## **BID ADDENDUM NO. 5**

July 22, 2026  
Alfred Almond CSD  
2025 Capital Project  
2028-059

SED #02-01-01-04-0-001-037 – K-12 Main Campus Building

### 3 CROSSWALK STRIPING

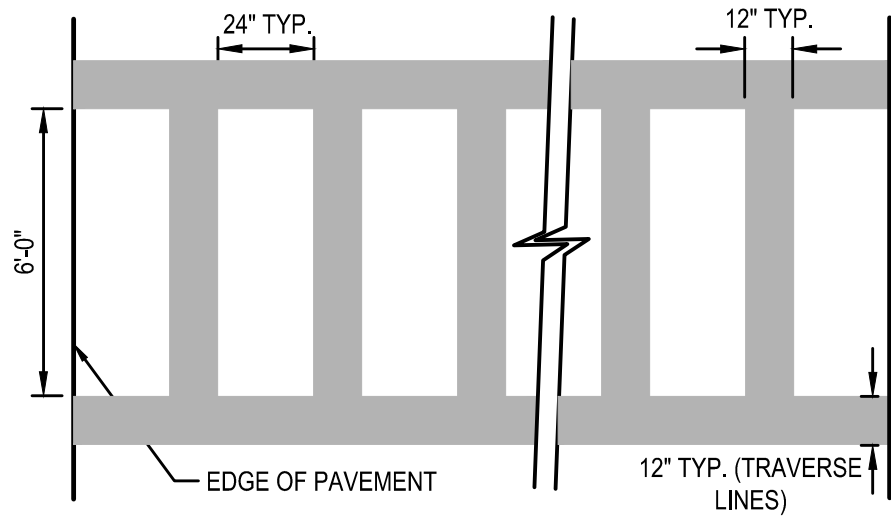
**ITEM AD5-11 Refer to MC-L4.1 – SITE DETAILS**

**ADD** Detail #3 per AD5-L1 as issued by this addendum.

### 2 SITE IMPROVEMENT PLAN

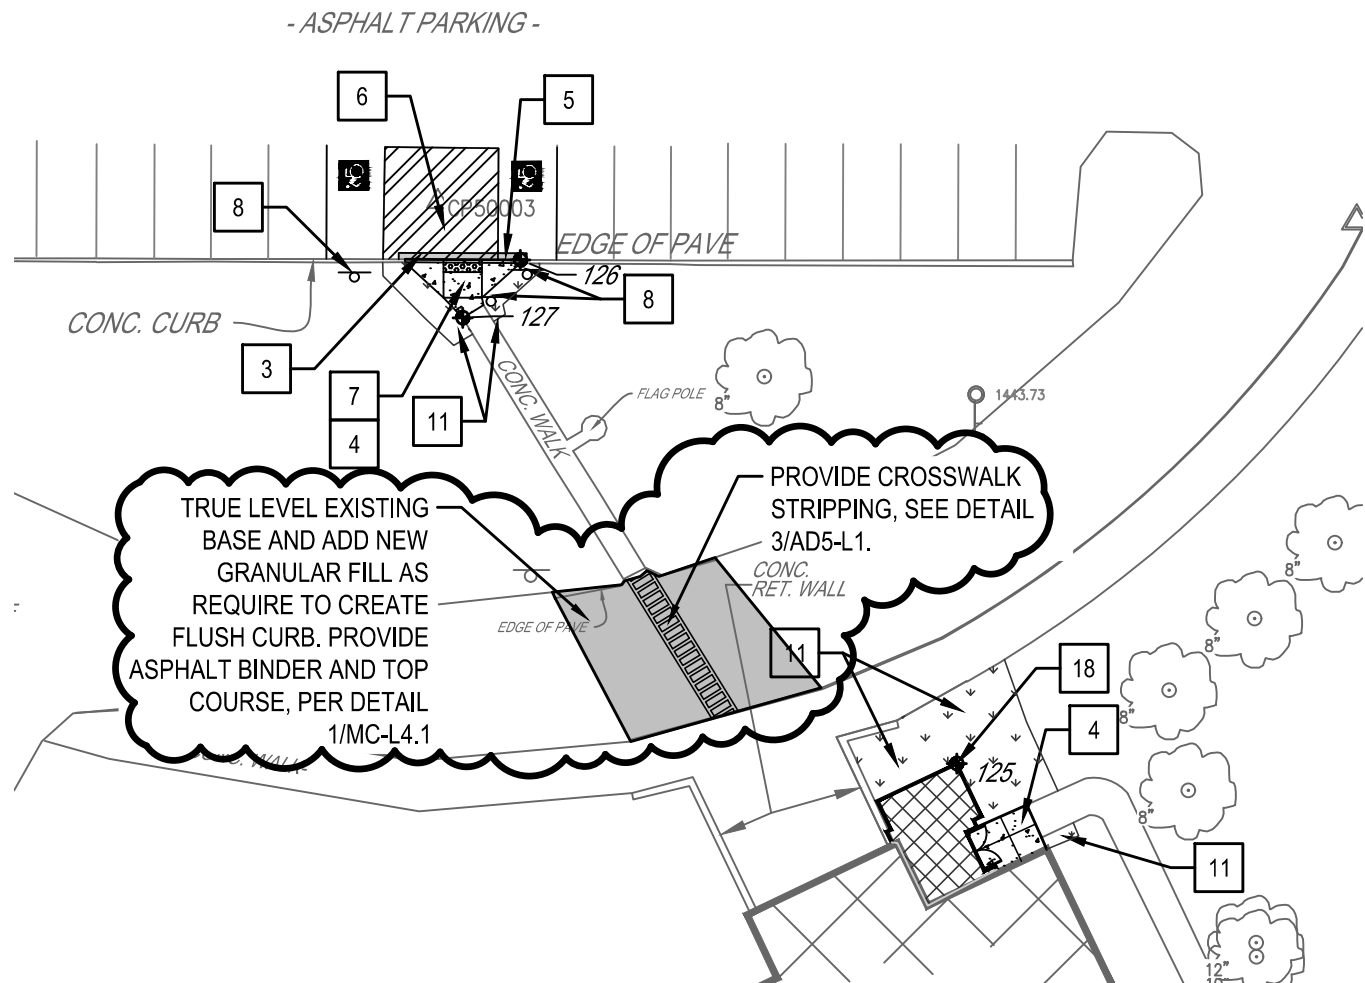
**ITEM AD5-10 Refer to MC-L2.2 – SITE IMPROVEMENT PLAN - NORTHWEST**

**AMEND** Detail #1 as per Detail #2 on AD5-L1 as issued by this addendum.

### 1 SITE DEMOLITION PLAN

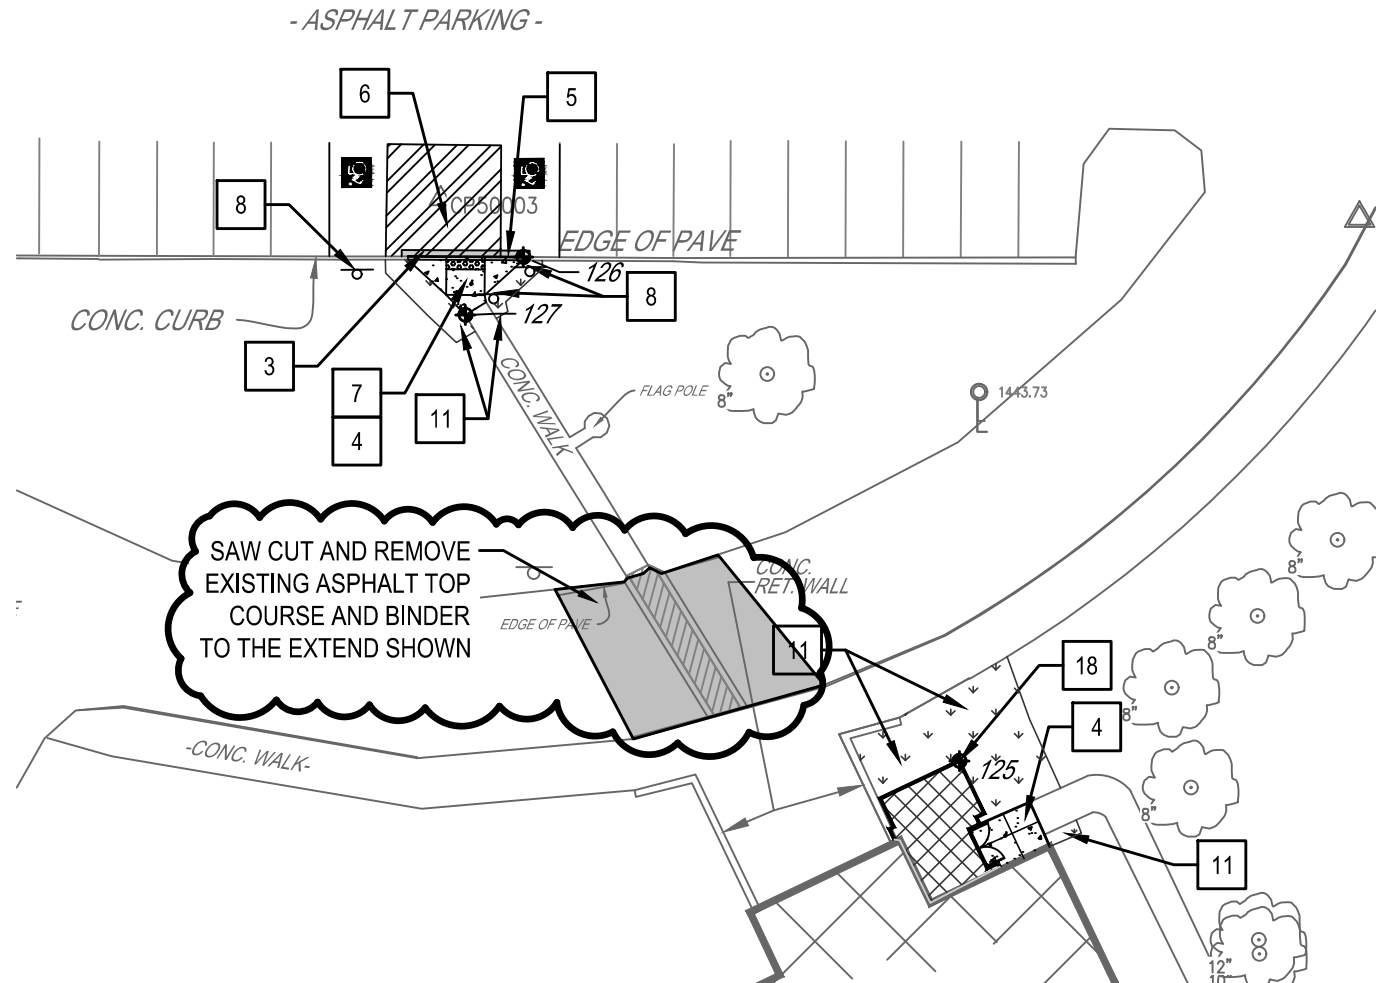
**ITEM AD5-9 Refer to MC-L1.2 – SITE DEMOLITION PLAN - NORTHWEST**

**AMEND** Detail #1 as per Detail #1 on AD5-L1 as issued by this addendum.
